**Quality Control Check Report. Stage: Before Casting Plinth Beam (Villas)**

Block No.	23	Sl. No.	32024
Company	Severe Construction	Phase	→
Prepared by	P. Sai Kumar	Date	10/11/18
Project Manager	Sarwan	Date	10/11/18
Previous stage report no.	30983	Report filed and signed by PM?	<input checked="" type="checkbox"/> Yes <input type="checkbox"/> No
Checked By MD on	MD Sign	For filling	<input type="checkbox"/> Yes <input type="checkbox"/> No

Description	Direction	Owners & Developers :	Date :	Promoted by
QC PLAN - 1200 SFT PLINTH BEAM	N	Modi Properties Pvt Ltd. Project Name & Phase : Serene Farms (Venkapatly)	08/08/18 Prepared By : Madhav Approved By : Soham Modi Scale : N.T.S	Modi Properties Pvt. Ltd. Phone: +91-40-66335551

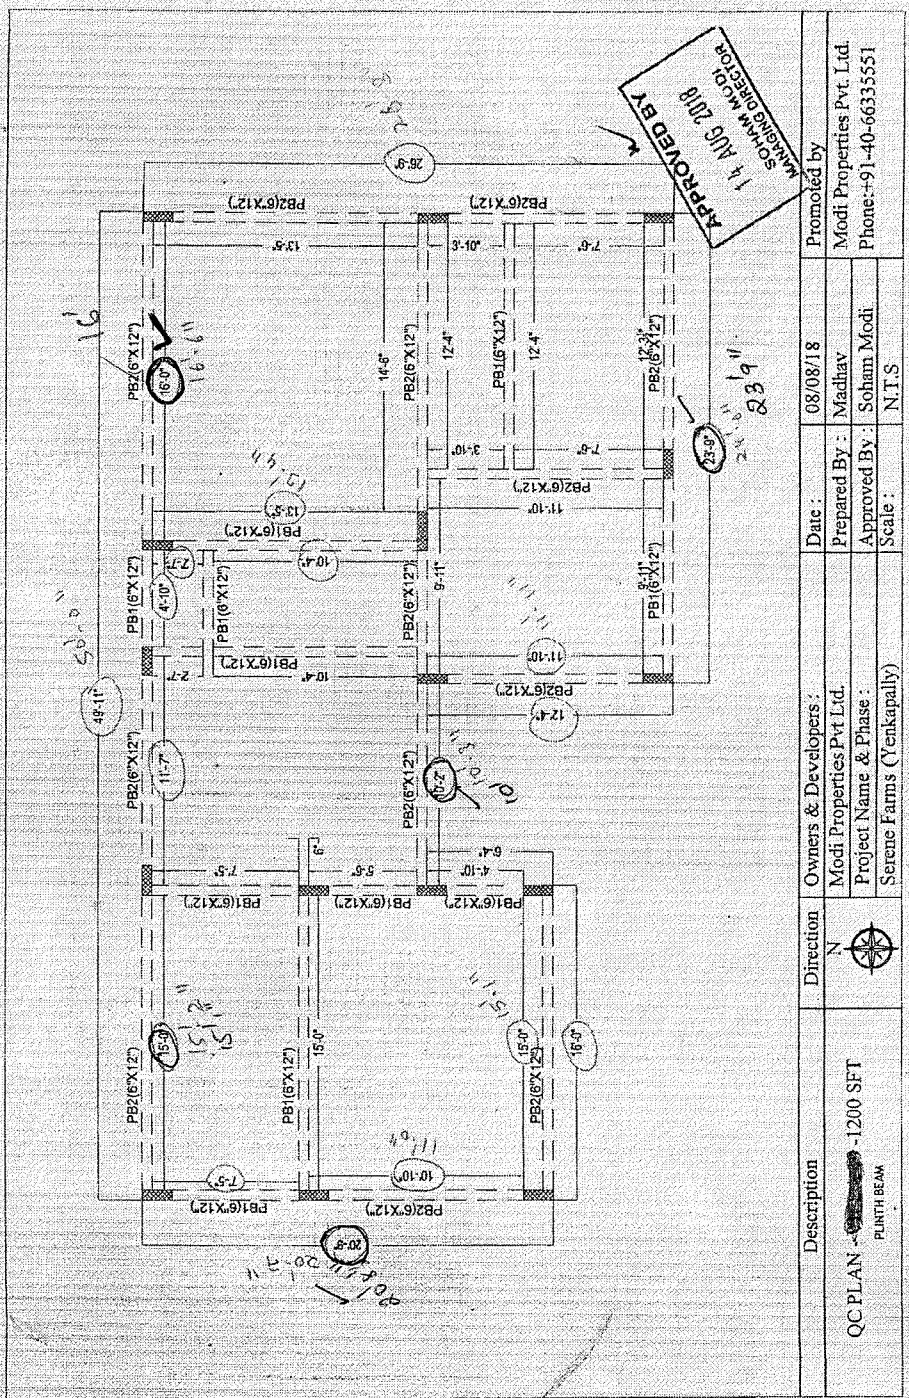
6.	Covering blocks for beams	✓	<input checked="" type="checkbox"/> Good <input type="checkbox"/> Avg. <input type="checkbox"/> Bad
7.	Depth and width of beams	✓	<input type="checkbox"/> Good <input checked="" type="checkbox"/> Avg. <input type="checkbox"/> Bad
Remarks:

Remarks: NOTE: POINTS which are mentioned by QC is corrected.
